AGENDA
CALIFORNIA TRAFFIC CONTROL DEVICES COMMITTEE (CTCDC)
June 14, 2006 Meeting
3333 Fairview Road, Costa Mesa, CA 92626
TIME 9:00 AM

06-4 Older California Traffic Safety Task Force Proposal for inclusion into the California Supplement

**Final recommendations approved per
CTCDC Workshop of February 22, 2006 and
proposed for inclusion into the California MUTCD**

Figure 3D-102(CA)

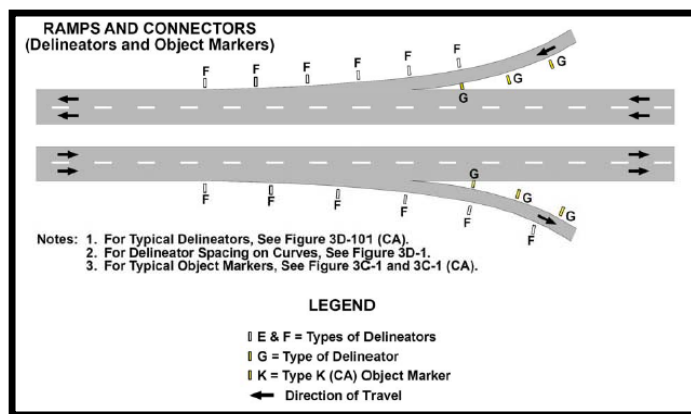
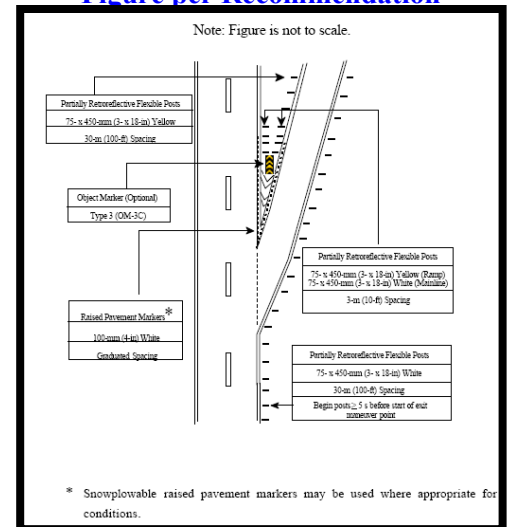
Figure 3D-102(CA) sketch will be revised and added as sheet 2 of 2 per application of this recommendation.

If the exit gore at an interchange is not illuminated or is partially illuminated, delineators may be placed as shown in Figure 3D-102(CA) per the following details:

- a) Type F - White Retroreflectors (1 Sided) on the right side, beginning at a distance > 5S from the theoretical gore point at 30 m (100 ft) spacing.
- b) Type G - Yellow Retroreflectors (1 Sided) on the left side of the exit at 3 m (10 ft) spacing and then shifting to 30 m (100 ft) spacing.
- c) Type F - White Retroreflectors (1 Sided) on the right side of the mainline, downstream of the exit at 3 m (10 ft) spacing.

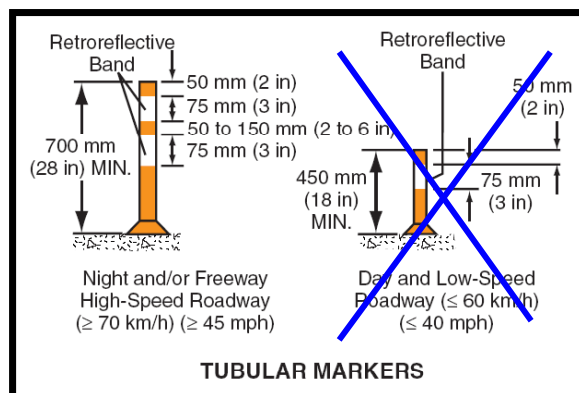
Cones (see Figure 6F-7, Sheet 1 of 2) shall be predominantly orange and shall be made of a material that can be struck without causing damage to the impacting vehicle. For daytime and low-speed roadways, cones shall be not less than ~~450 mm (18 in)~~ **700 mm (28 in)** in height. When cones are used on freeways and other high-speed highways or at night on all highways, or when more conspicuous guidance is needed, cones shall be a minimum of 700 mm (28 in) in height.

Cones should be a minimum of 900 mm (36 in) in height.

Retroreflectorization of cones that are more than 900 mm (36 in) in height should be provided with a retroreflective material totaling at least 300 mm (12 in) wide at night.

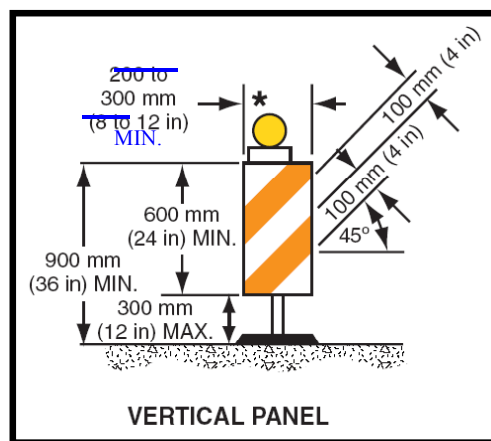
Tubular markers (see Figure 6F-7, Sheet 1 of 2) shall be predominantly orange and shall be not less than ~~450 mm (18 in)~~ **700 mm (28 in)** high and 50 mm (2 in) wide facing road users. They shall be made of a material that can be struck without causing damage to the impacting vehicle.

Tubular markers should be a minimum of 1050 mm (42 in) in height.

Retroreflectorization of tubular markers that are more than 1050 mm (42 in) in height should be provided with a single 300 mm (12 in) wide white band at night.

Table 6F-102(CA). Maximum Spacing of Channelizing Devices

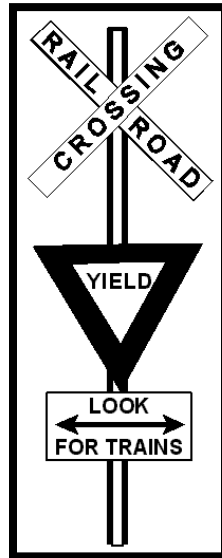
The spacing of channelizing devices should not exceed a distance in meters (feet) equal to 0.2 times the speed limit in km/h (1.0 times the speed limit in mph) when used for taper channelization, and a distance in meters (feet) equal to 0.4 times the speed limit in km/h (2.0 times the speed limit in mph) when used for tangent channelization.

The spacing of channelizing devices should not exceed a distance in meters (feet) equal to 0.2 times the speed limit in km/h (1.0 times the speed limit in mph).

Where engineering judgment indicates a special need for speed reduction due to horizontal curvature or through the taper for a lane closure, the spacing of channelizing devices should not exceed a distance in meters (feet) equal to 0.1 times the speed limit in km/h (0.5 times the speed limit in mph).
